EMOC Project Presentation

Montgomery County, Maryland
Contract No. 7504510027 Task Order WD-01

Baker and Associates
July 20, 2009

Design response to community requests

Heat Islands (cont.)

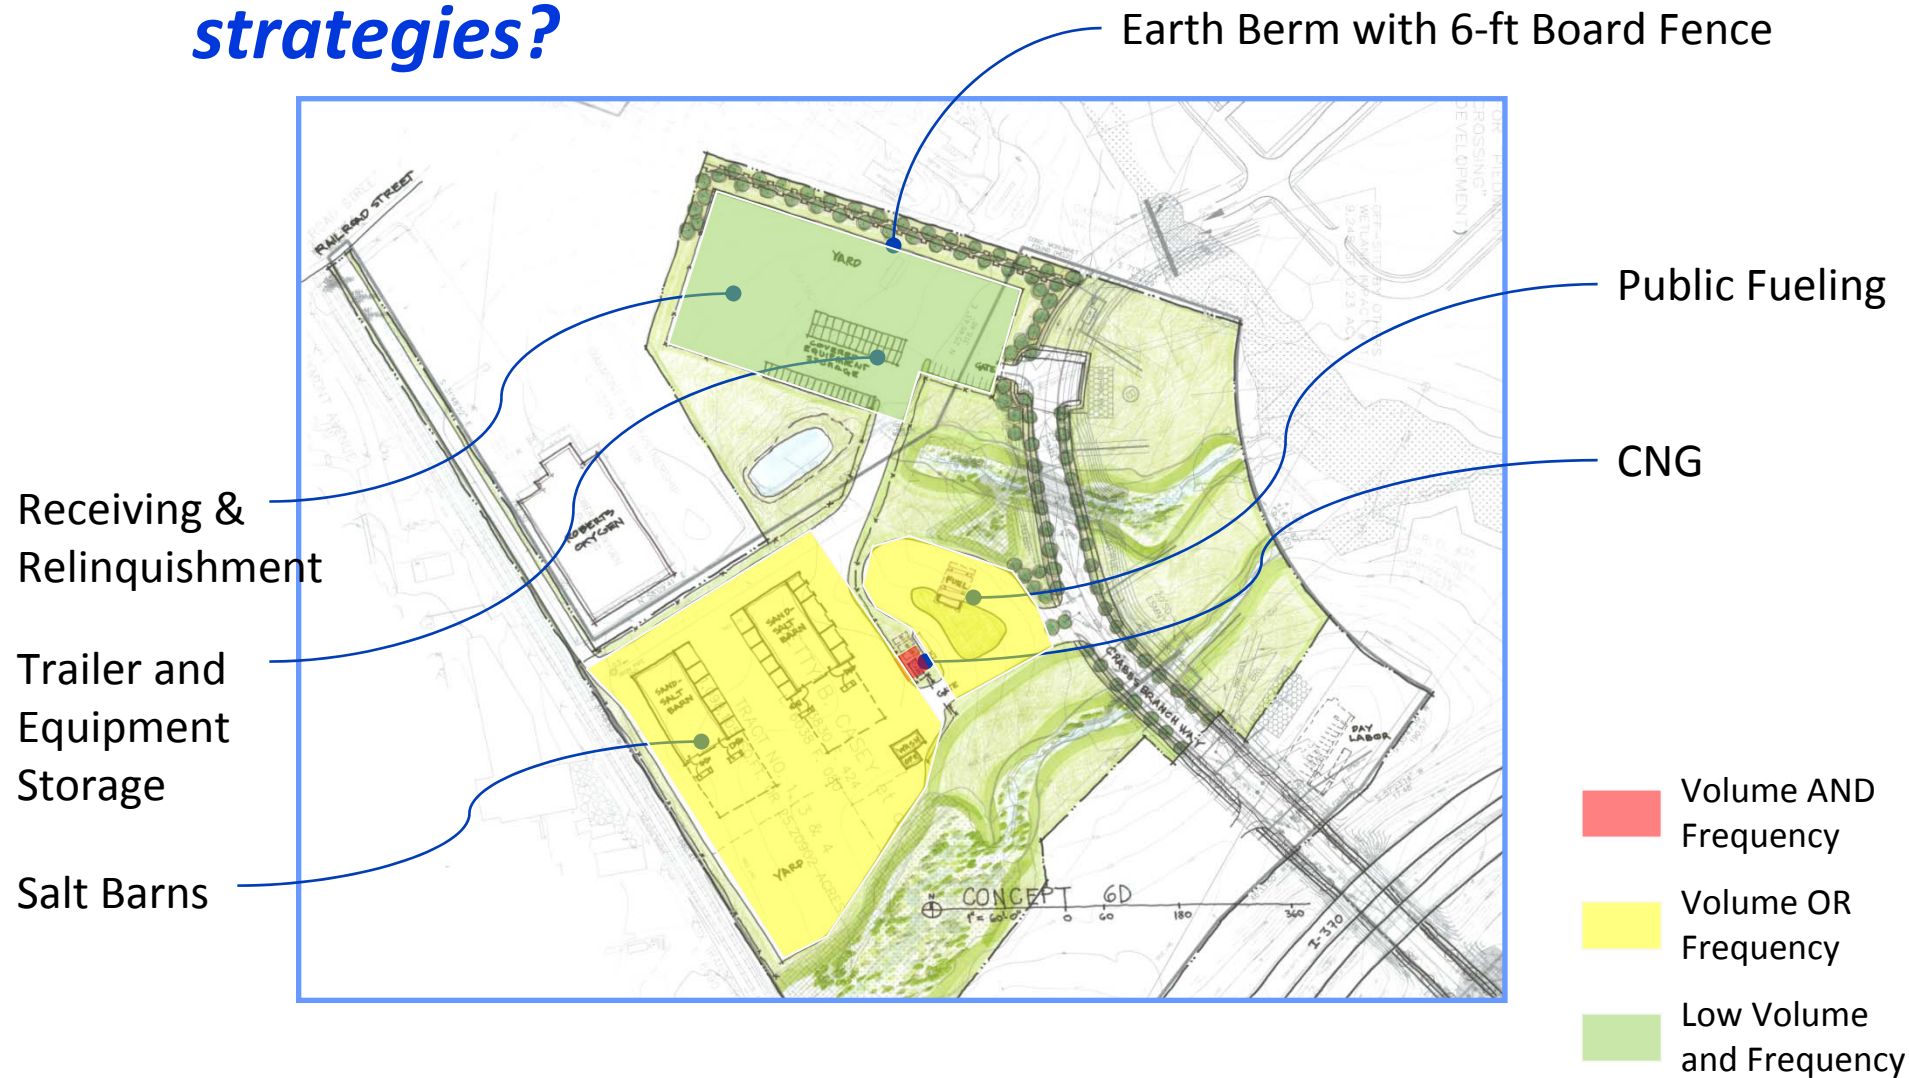
- *How will the project account for minimizing the heat island effect due to increased hardscape?*
- **SS-7.1: Heat Island Effect: Non-Roof**
 - Min. of 50% parking under cover with roof to have SRI of at least 29.

- Option 1: Roofing Material with Solar Reflectance Index (SRI) equal to or great than table for 75% of roof surface.

- Option 2: Install vegetated roof for at least 50% of roof area.
- Option 3: Install high albedo and vegetated roof surfaces that, in combination, meet criteria:

Noise Generation and Mitigation

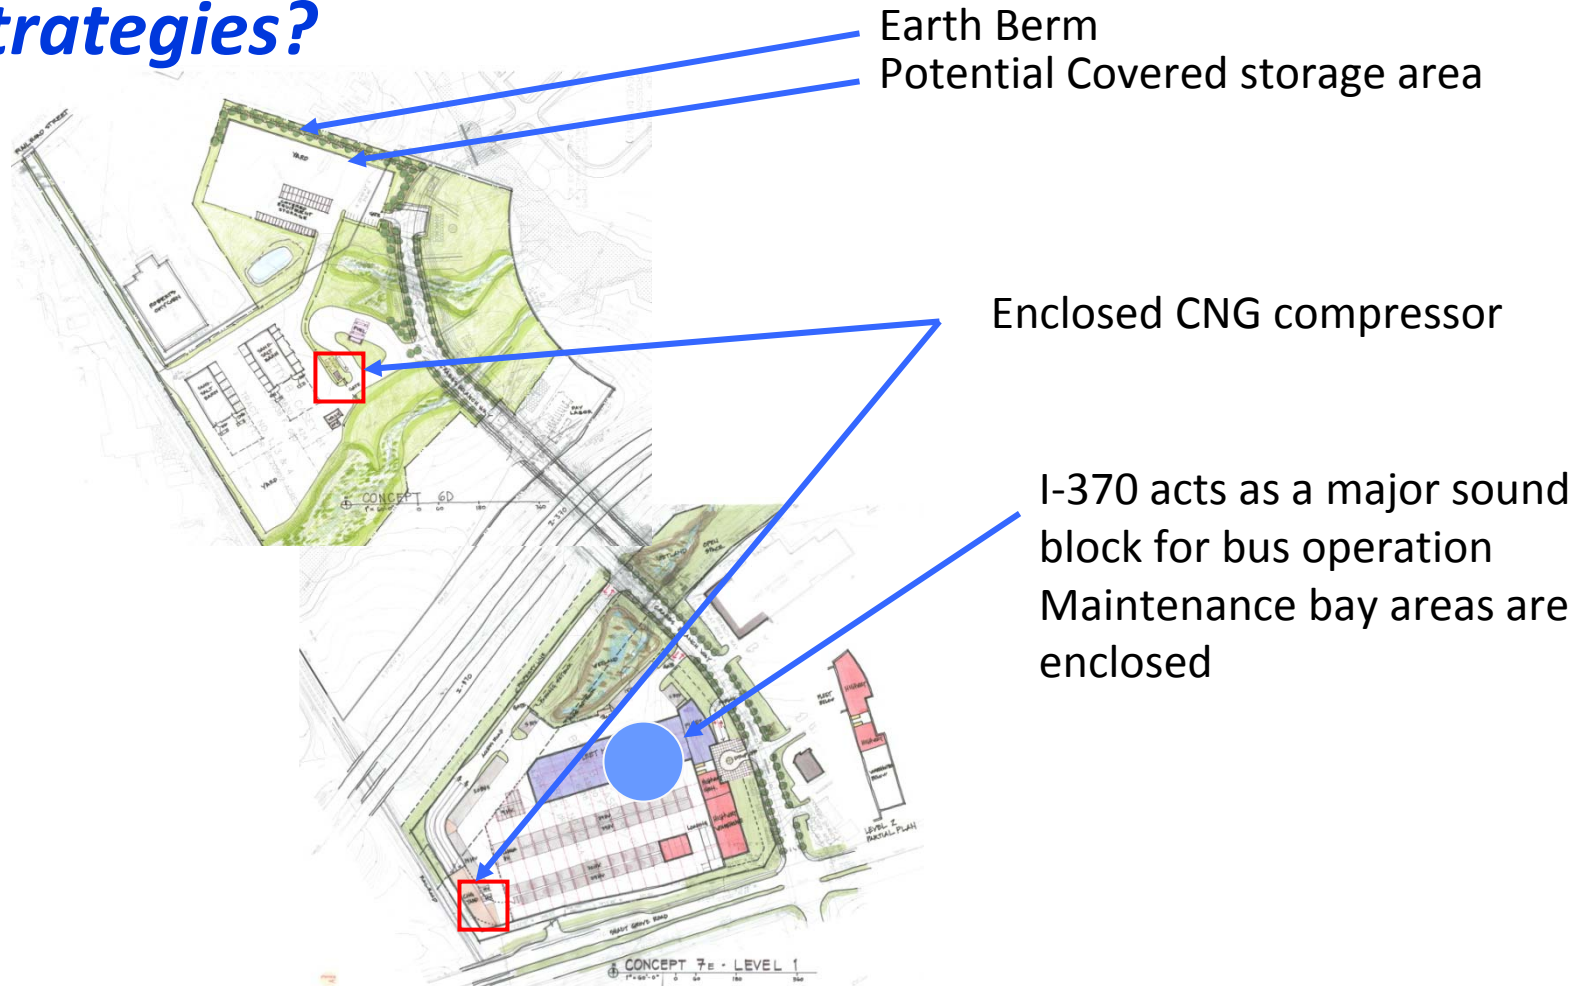
■ *What are the proposed noise mitigation strategies?*

Noise Generation and Mitigation

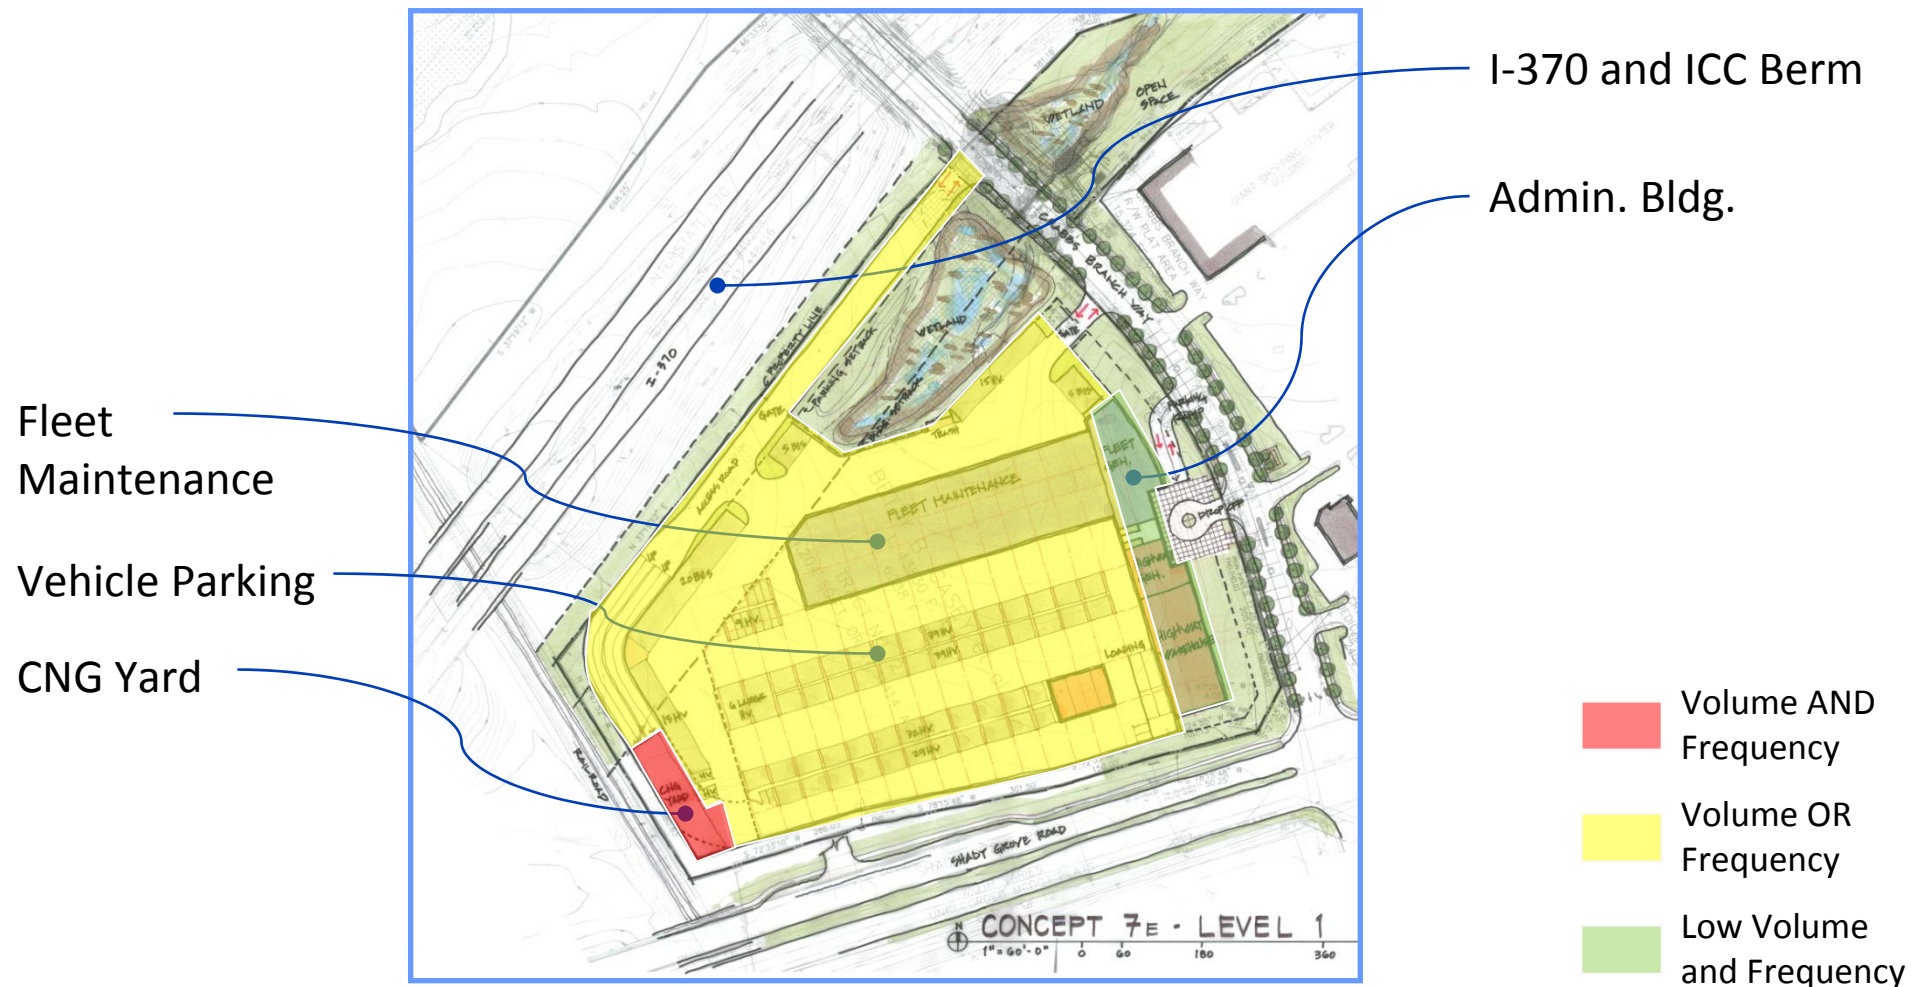
- *What are the proposed noise mitigation strategies?*

Access to Roberts Oxygen

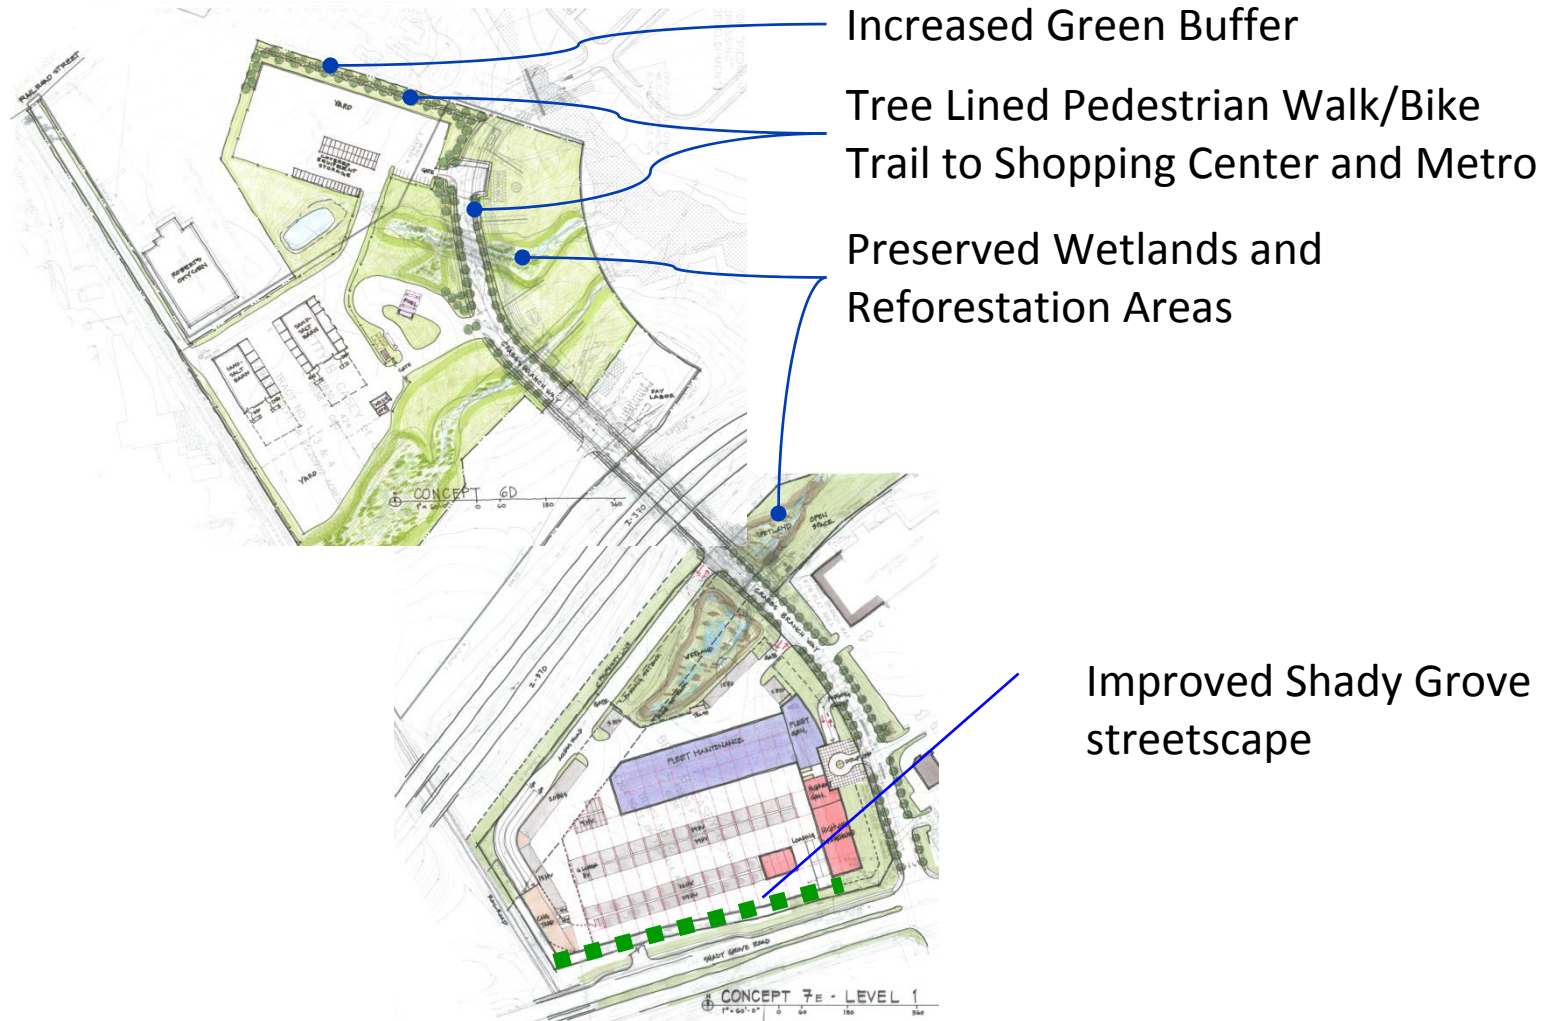
- *Q: Will there be an access driveway to Roberts Oxygen? If so, where?*
- *A: Under investigation – Not in the green buffer area*

Access to I-370

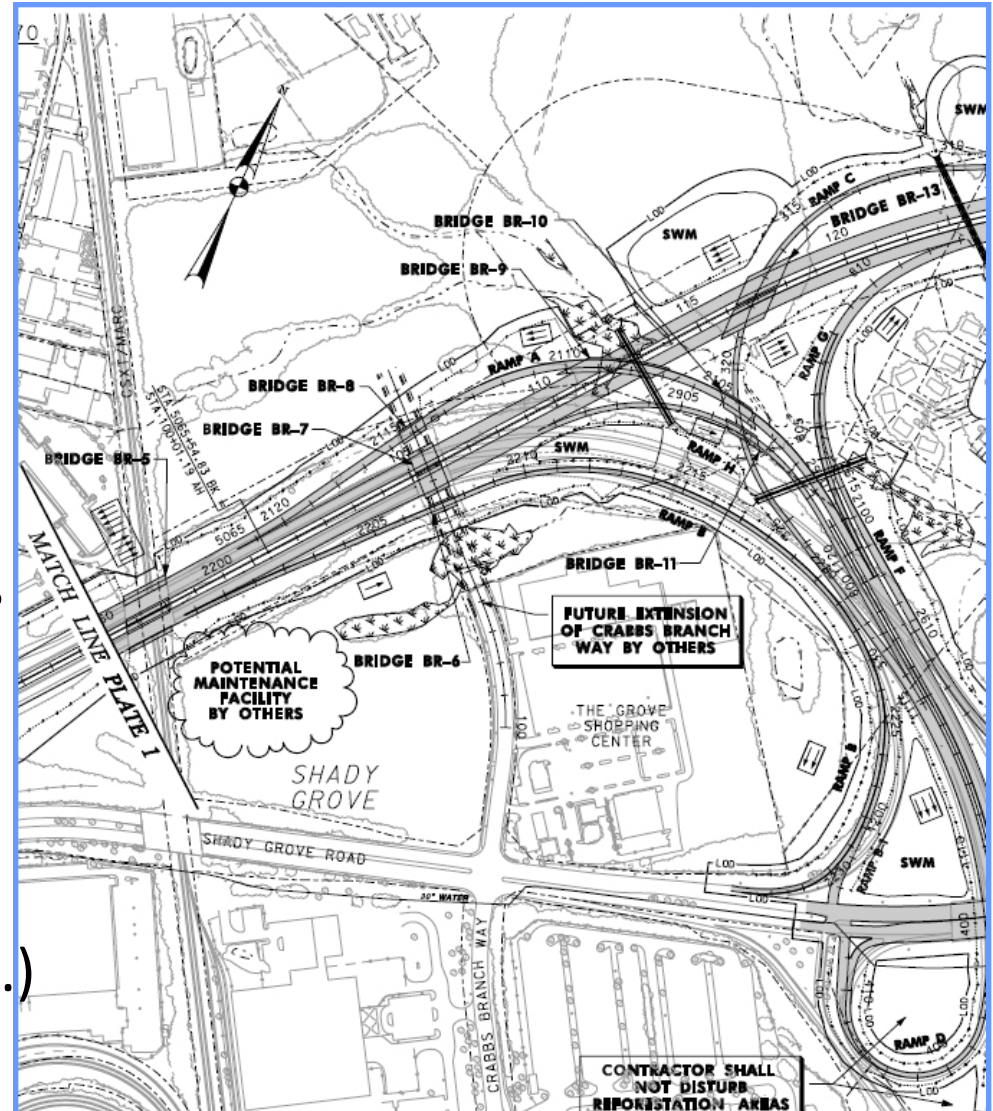
■ *Could the project incorporate an access directly to I-370?*

- Review period for an additional ramp would be between 3-5 years.
- Ramps are typically 2 miles apart.
- Site is too small for access ramp requirements (acceleration / deceleration.)
